UNITED STATES PATENT AND TRADEMARK OFFICE

APPLICATION NO.	FILING DATE	FIRST NAMED INVENTOR	ATTORNEY DOCKET NO.	CONFIRMATION NO.
10/589,753	05/20/2008	Enrique Kogan-Frenk	3446-101	9668

Office Action Summary	Application No. 10/589,753	Applicant(s) KOGAN-FRENK, ENRIQUE	
	Examiner Michael R. Ballinger	Art Unit 3732

DETAILED ACTION

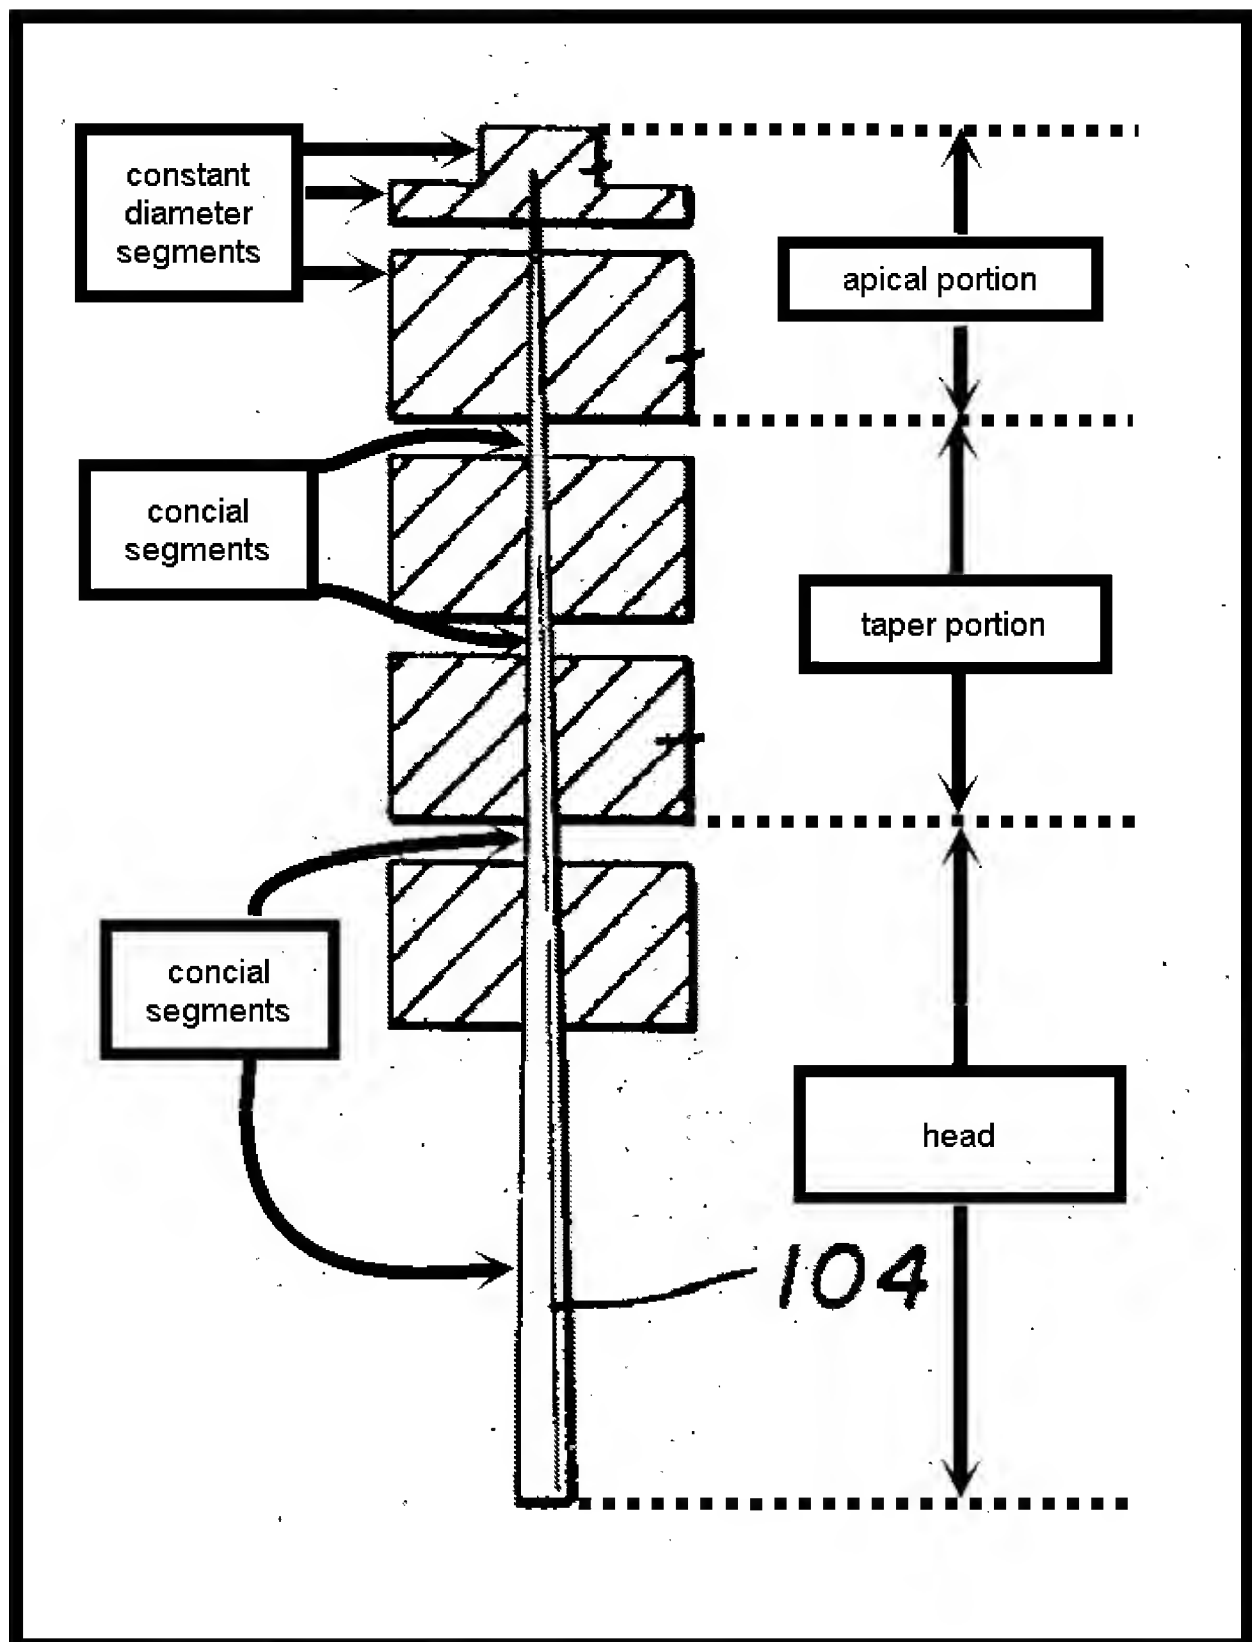
14. Claims 11 is rejected under 35 U.S.C. 102(b) as being anticipated by Malmin (U.S. 3,949,479).

15. Per claim 11, figure 14 of Malmin teaches an intra-radicular post of adjustable dimensions, for rebuilding of teeth, with treatment passages, including an apical portion (as illustrated below), formed by constant diameter segments (as illustrated below, the Examiner notes, the segments shown below are of constant diameter because each segment has a constant diameter), a tapered body (as illustrated below), formed by conical segments (i.e., the tapered portions of the metal core pin, 104 as illustrated below) and adjacent the apical portion; and a head (as illustrated below), formed by conical segments (as illustrated below), and adjacent to the tapered body.

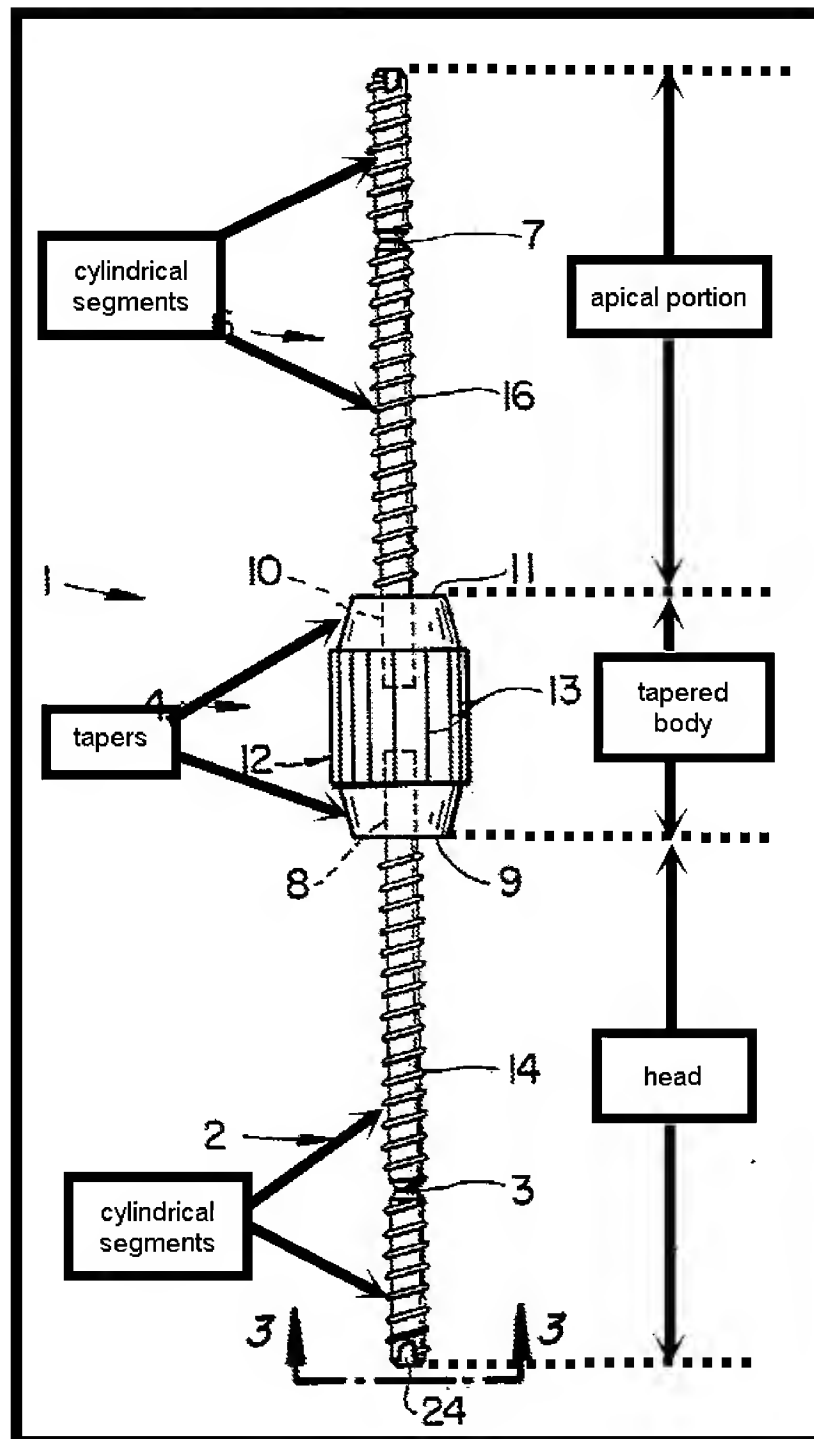
16. Claims 18-20 are rejected under 35 U.S.C. 102(b) as being anticipated by Rovins (U.S. 4,171,569).

17. Per claims 18-20 figure 1 of Rovins teaches an intra-radicular post of adjustable dimensions, for rebuilding of teeth, with treatment of the passages, including an apical portion (6) formed by a plurality of cylindrical segments (i.e., shaft 6, where the segments are delineated by the fracture groove, 7), a taper body (i.e., the handle 4 has a tapered portion at each end, as illustrated below) adjacent to the apical portion (6), a head (i.e., shaft, 2) adjacent the body, formed by a plurality of cylindrical segments (i.e., shaft 2, where the segments are delineated by the fracture groove, 3); where upon the post height can be modified by realizing a cut in the apical portion (at the fracture groove, 7) and a cut in the post head (at the fracture groove, 3). The Examiner notes that "whereupon the post height can be modified by realizing at least one of up to two cuts in the apical portion and up to three cuts in the post head" is a functional limitation. A functional limitation use of the claimed invention must result in a structural difference between the claimed invention and the prior art in order to patentably distinguish the claimed invention from the prior art. If the prior art structure is capable of performing the intended use, then it meets the claim. In the instant case, the device of Rovins is capable of being cut at least at the fracture grooves (3 and 7) and could additionally be cut anywhere along the length of the device multiple times. As such, the Examiner submits, the device of Rovins anticipates claims 18-20 as claimed.

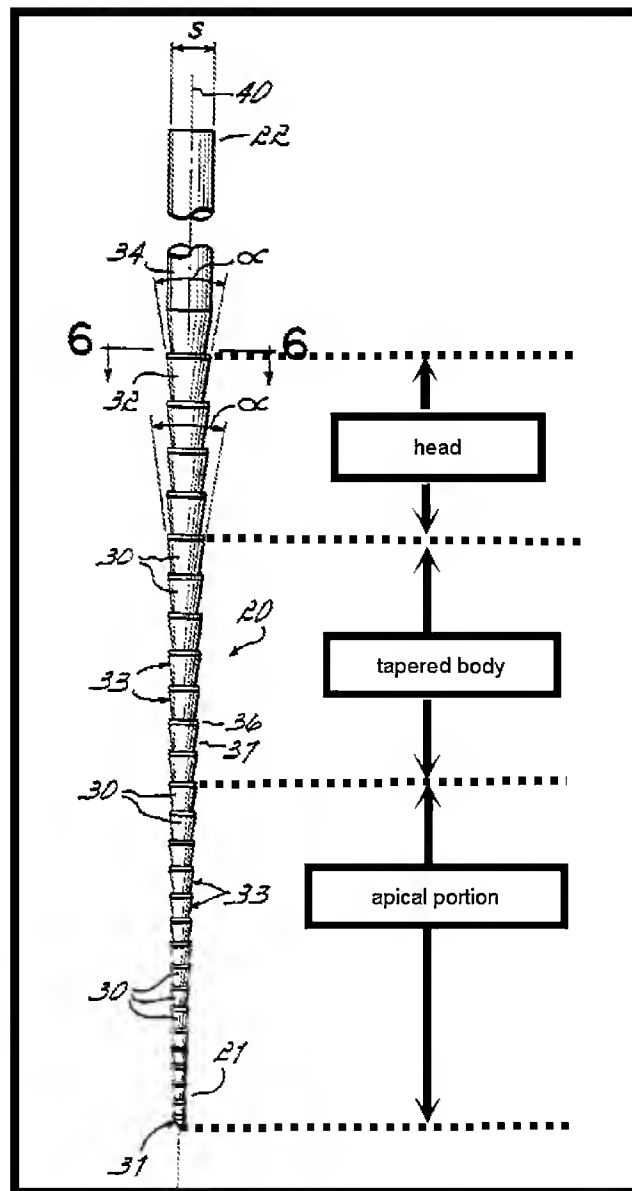
24. Per claim 15, figure 3 of Garman teaches the head comprises two lateral flat faces (i.e., legs, 69).
